To: T10 Technical Committee
 From: Jay Neer (Jay.Neer@Molex.com)
 Date: February 23, 2005
 Subject: SAS 1-1 Compact Connectors (Internal and External)

This proposal has been prepared in the style of SAS 1-1 Rev 8. Changes and additions to the relevant sections of 5.2.3 and 5.2.4 are identified.

Figure 61C — SAS external compact cable plug connector

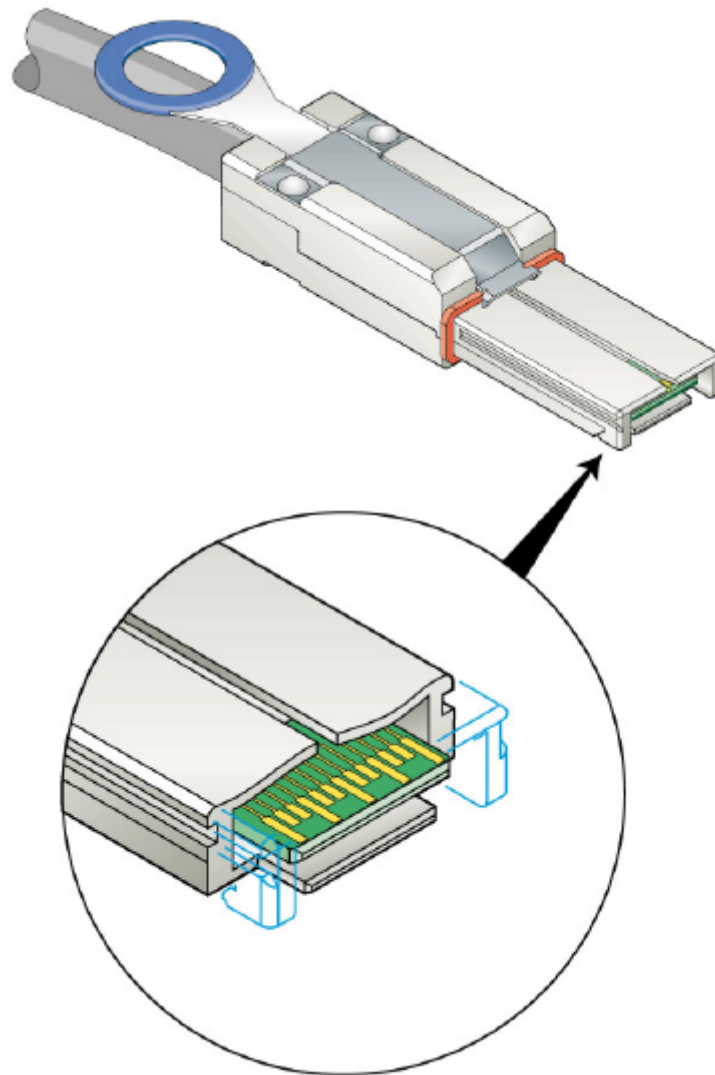
The SAS external compact cable plug connector is defined in SFF-8088 as the four lane free (plug) connector with latch. The SAS external compact cable plug connector shall not include keys and may include key slots. Key slots are not defined by this standard. The SAS external compact cable plug connector attaches to a SAS external compact receptacle connector, providing contact for up to four physical links.

Figure 61C shows the SAS external compact cable plug connector.

Figure 62C — SAS external compact receptacle connector

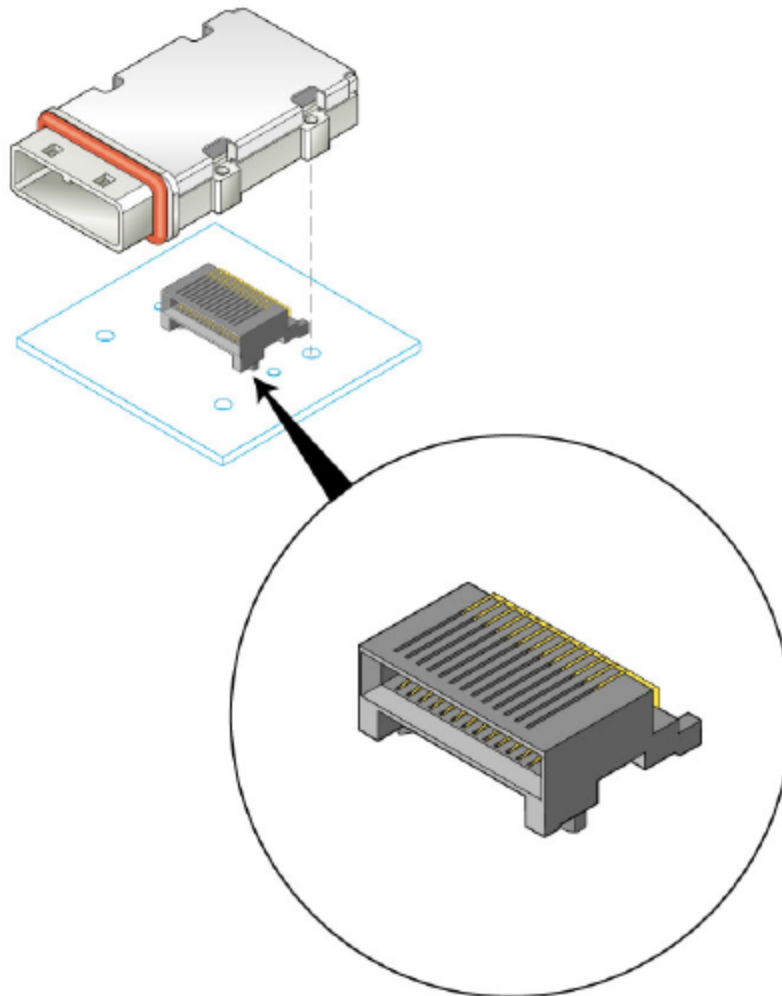
SAS devices with external ports shall use the SAS external compact receptacle connector. The SAS external compact receptacle connector is defined in SFF-8088 as the four lane fixed (receptacle) connector with latch.

The SAS external compact cable receptacle connector shall not include keys and may include key slots. Key slots are not defined by this standard. The SAS external compact receptacle connector attaches to a SAS external compact cable plug connector, providing contact for up to four physical links.

Figure 62C shows the SAS external compact receptacle connector.

Figure 63CW — SAS internal compact wide cable plug connector

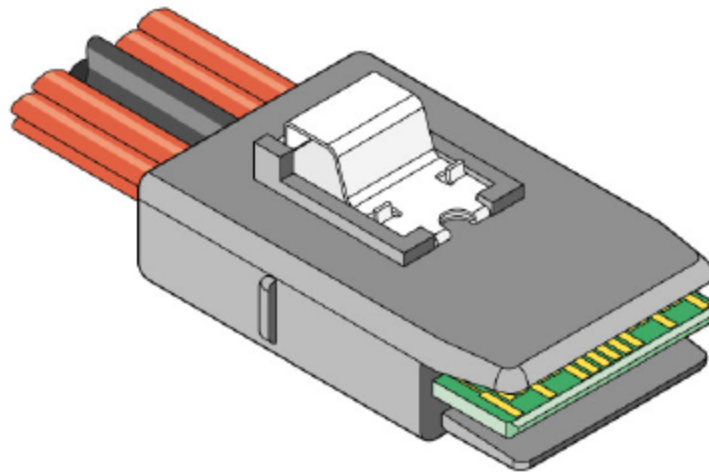
The SAS internal compact wide cable plug connector is defined in SFF-8087.

The SAS internal compact wide cable plug connector attaches to a SAS internal compact wide receptacle connector, providing contact for up to four physical links and six sideband signals.

Figure 63CW shows the SAS internal compact wide cable plug connector.

Figure 64CW — SAS internal compact wide receptacle connector

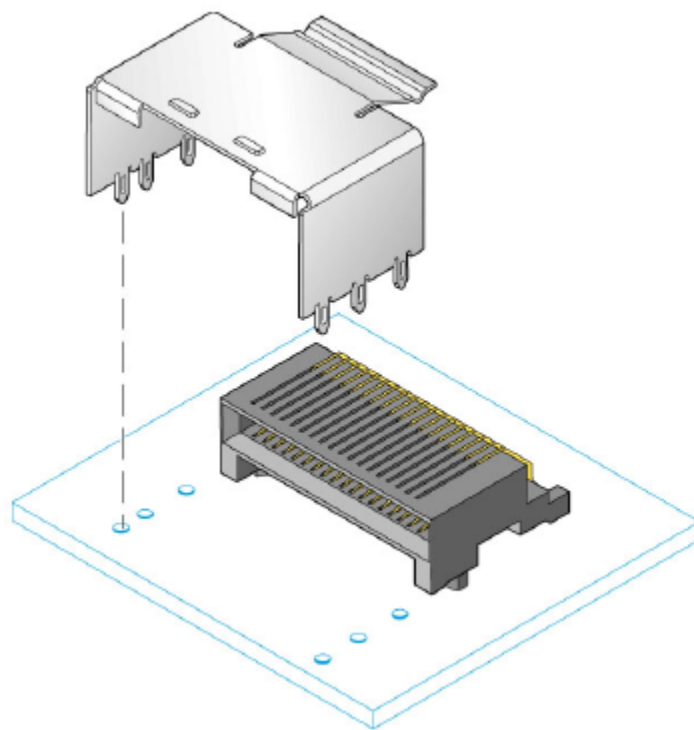
The SAS internal compact wide receptacle connector is defined in SFF-8087.

The SAS internal compact wide cable plug connector attaches to a SAS internal compact wide receptacle connector, providing contact for up to four physical links and six sideband signals.

Figure 64CW shows the SAS internal compact wide receptacle connector.

FIGURE 6767CW - SAS internal compact wide cable attaching controller to backplane

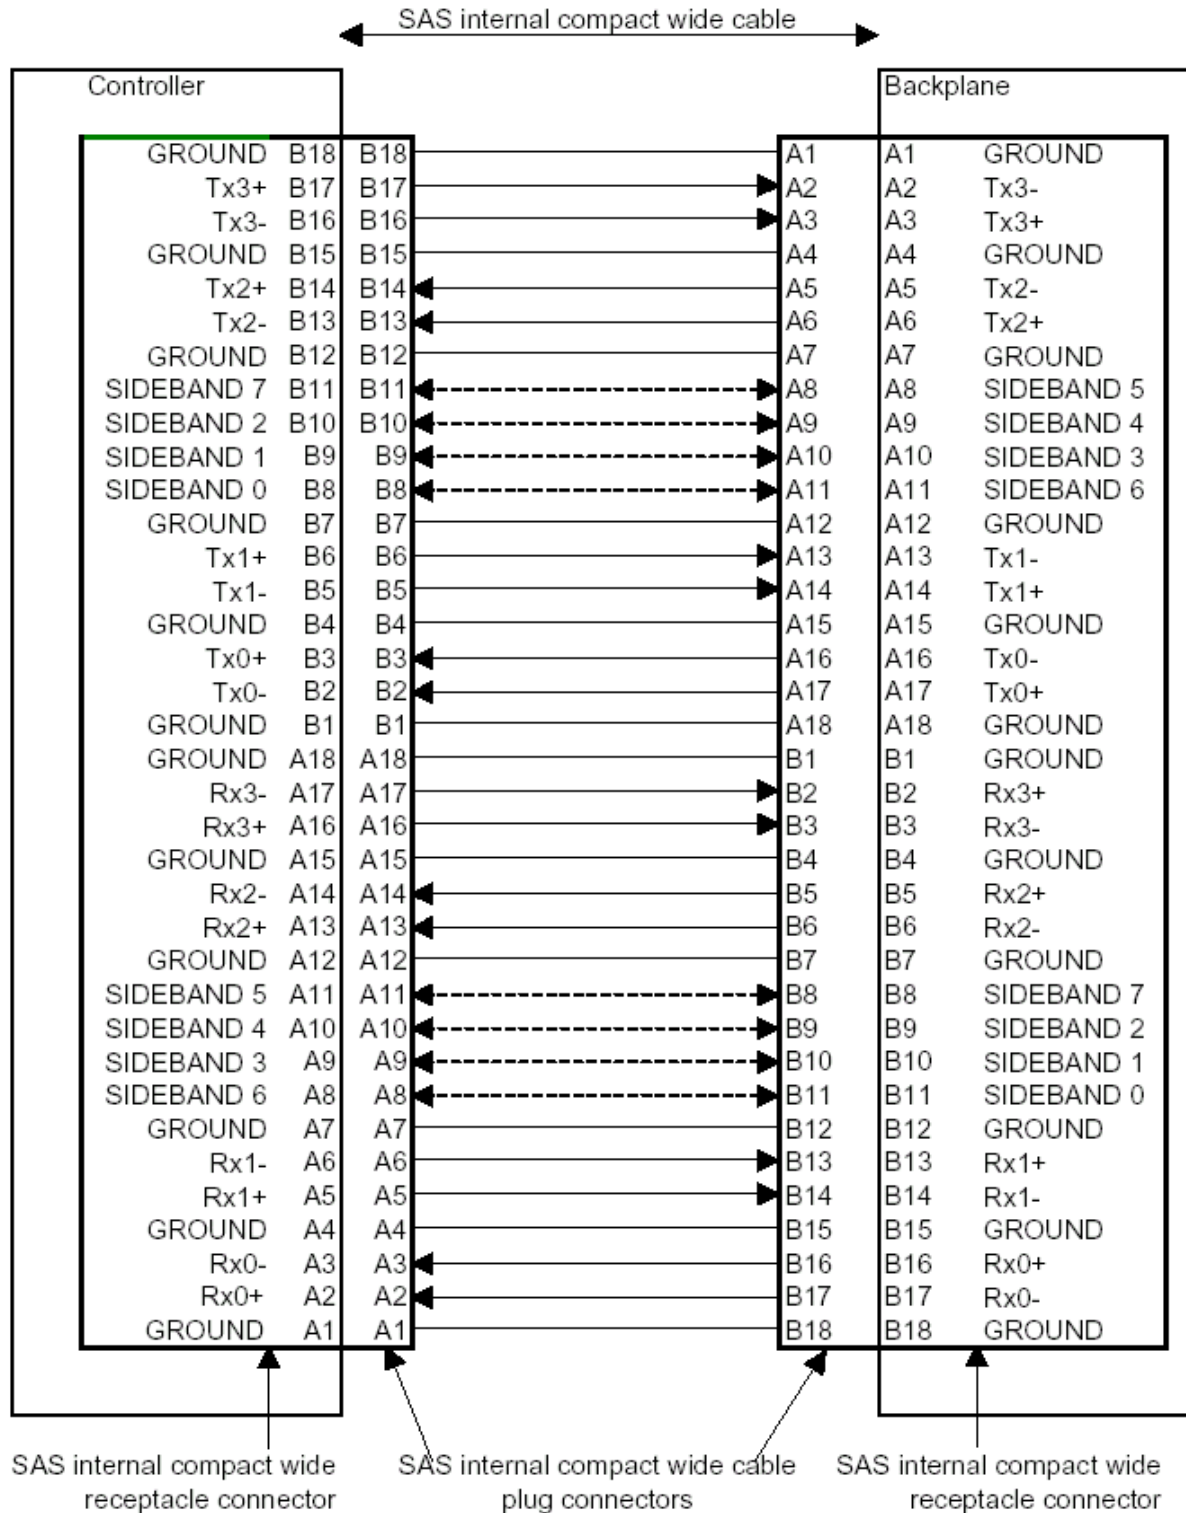
Figure 6767CW shows the SAS internal compact wide cable being used to attach a controller to a backplane.

Note: The backplane connector pin assignments are different from the controller in order to create a null modem. The transmit and receive rows are exchanged and mirrored.

NOTE 8 - For controller to backplane uses, up to four physical links may be used. SIDE BAND signals on the controller are attached to the corresponding SIDE BAND signals on the backplane (e.g., SIDE BAND 0 of the controller is attached to SIDE BAND 0 of the backplane).

FIGURE 6868CW - SAS internal compact wide cable attaching to controller

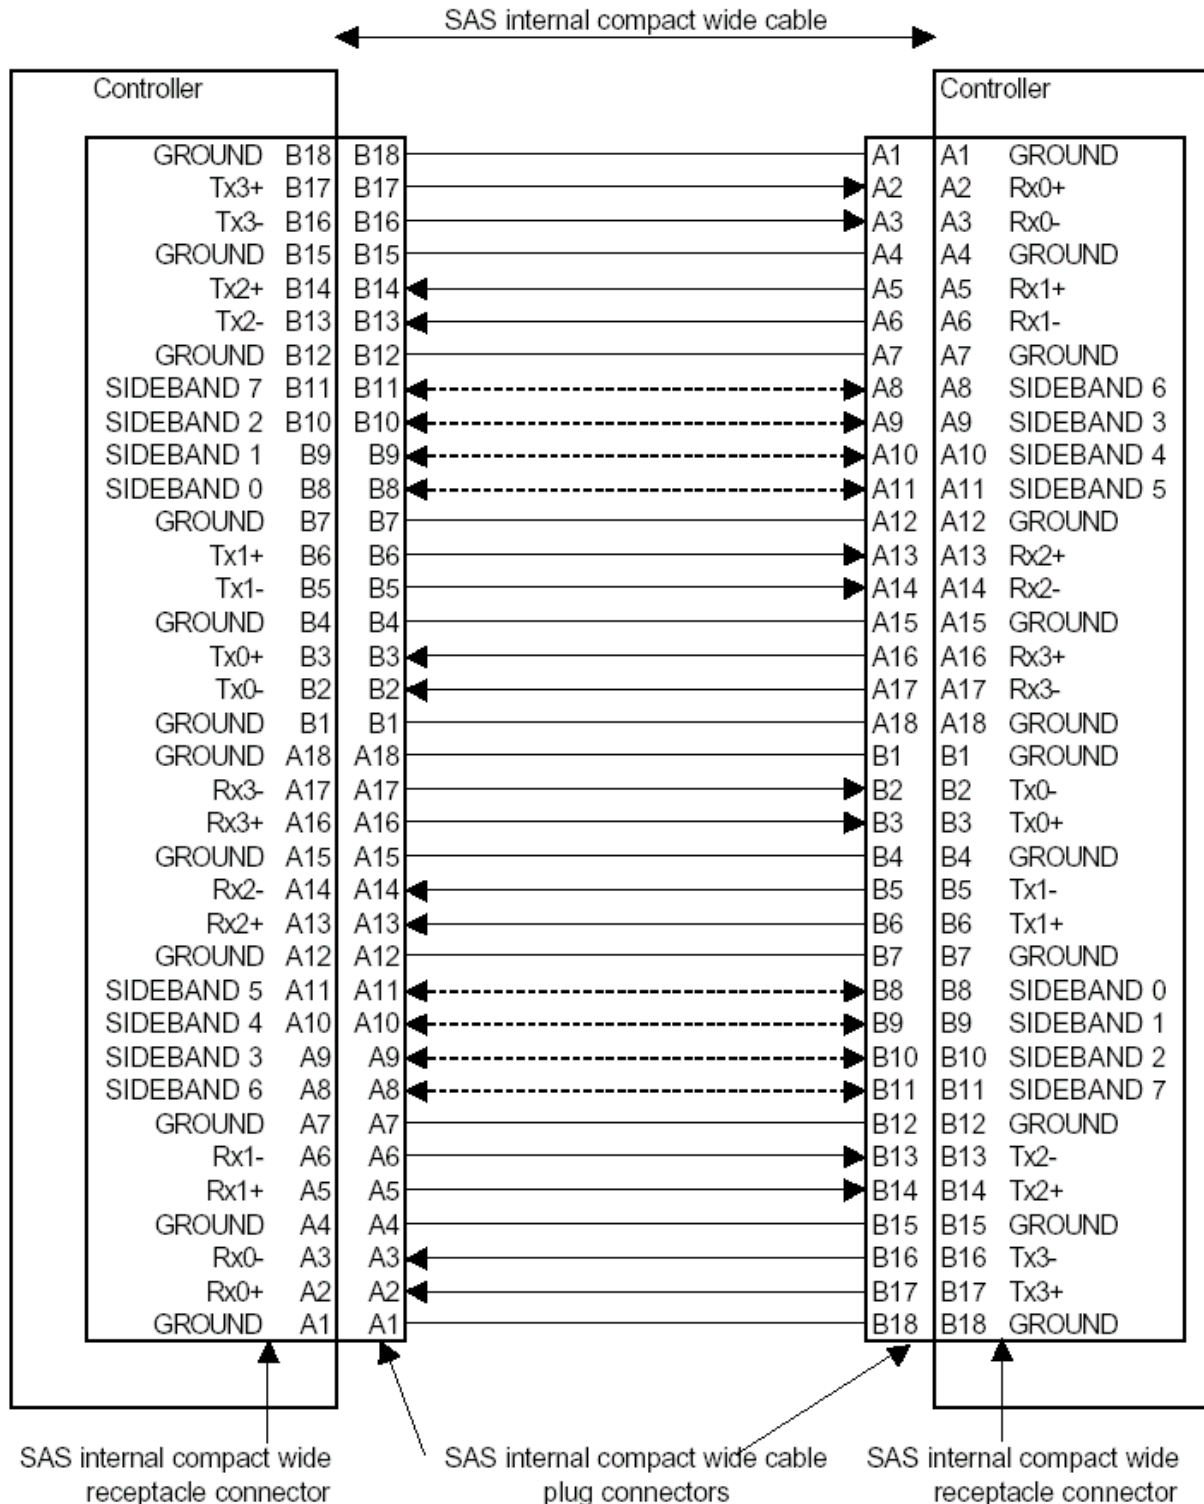
Figure 6868CW shows the SAS internal compact wide cable attaching two controllers.

NOTE 9 - For controller to controller uses, all four physical links should be used, because one controller's physical link 0 is attached the other controller's physical link 3. If both controllers used only physical link 0, they would not communicate.

NOTE 10 - For controller to controller uses, SIDE BAND signals on one controller are not attached to their corresponding SIDE BAND signals on the other controller (e.g, SIDE BAND 0 of one controller is attached to SIDE BAND 5 of the other controller).

FIGURE 6969CW - SAS internal compact wide controller-based fanout cable

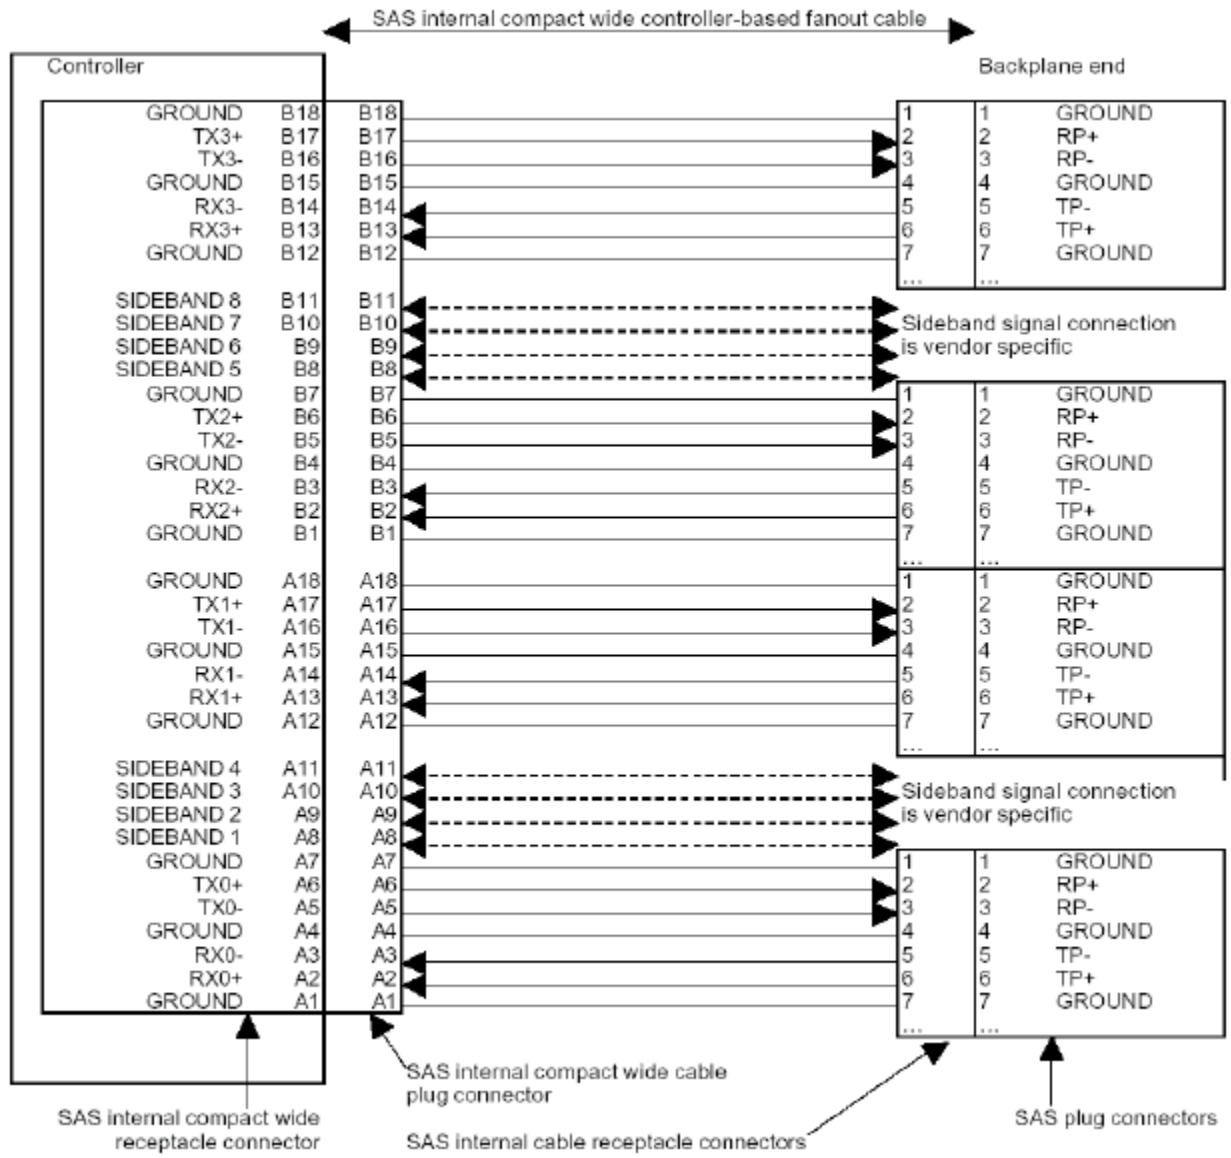
Figure 6969CW shows the SAS internal compact wide controller-based fanout cable.

FIGURE 7070CW - SAS internal compact wide backplane-based fanout cable

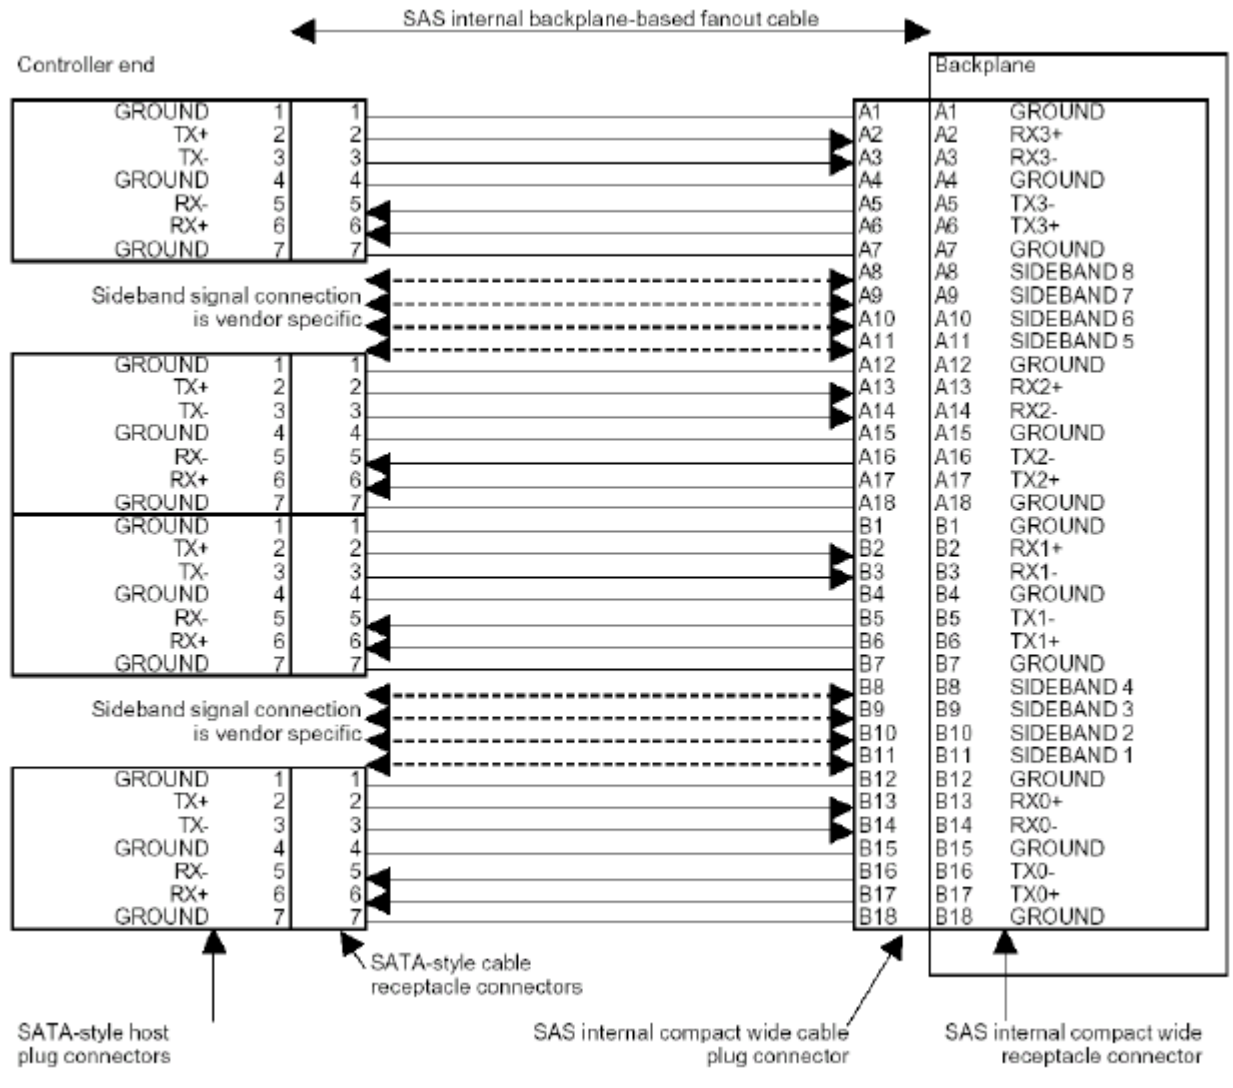
Figure 7070CW shows the SAS internal compact wide backplane-based fanout cable.
